# 4PID Ad hoc – Review (with notes)

IEEE 802.3: 4PPOE Task Force  
4PID Ad Hoc

George Zimmerman, Ph.D.  
CME Consulting

# Option comparison (darshan\_11)

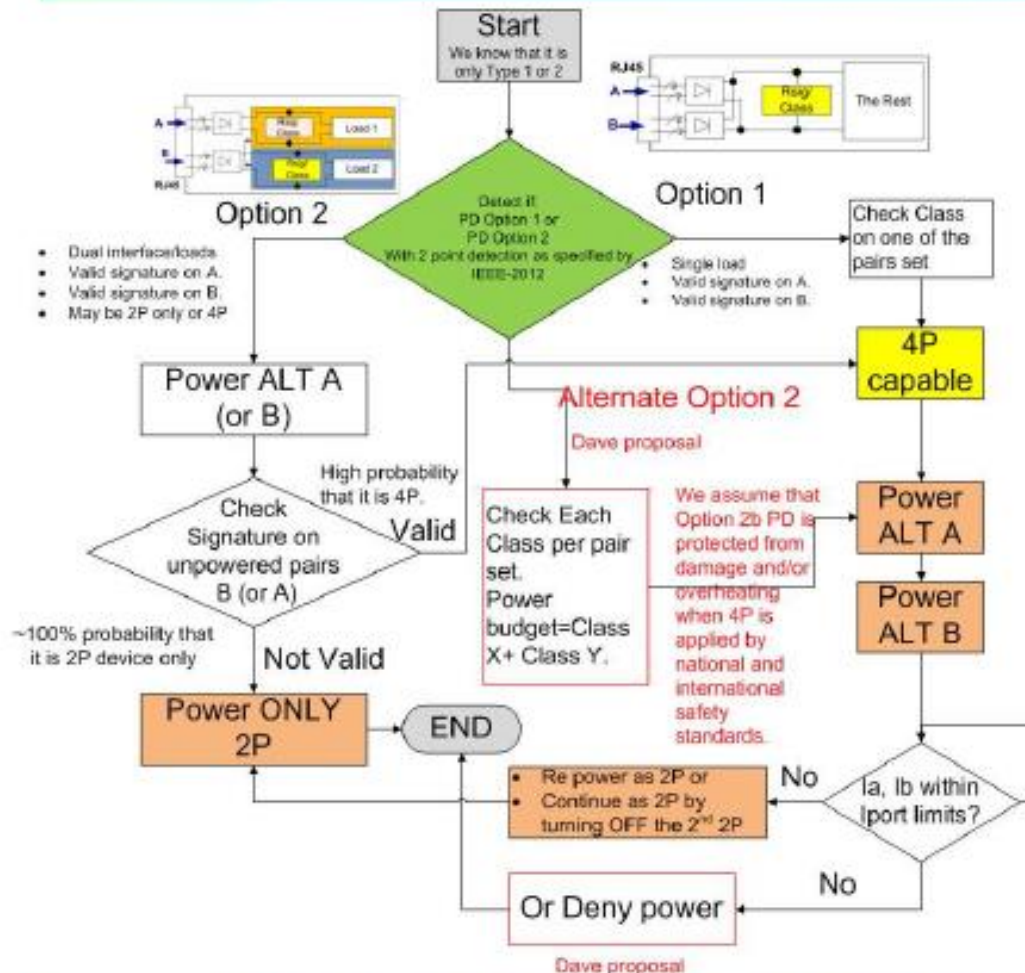
Green decision block and Option 1 branch appear agreed, assuming "Power ALT A" & "Power ALT B" blocks may either be joint or sequential (YD: agreed)

- Alternative Option 2 is marked red.
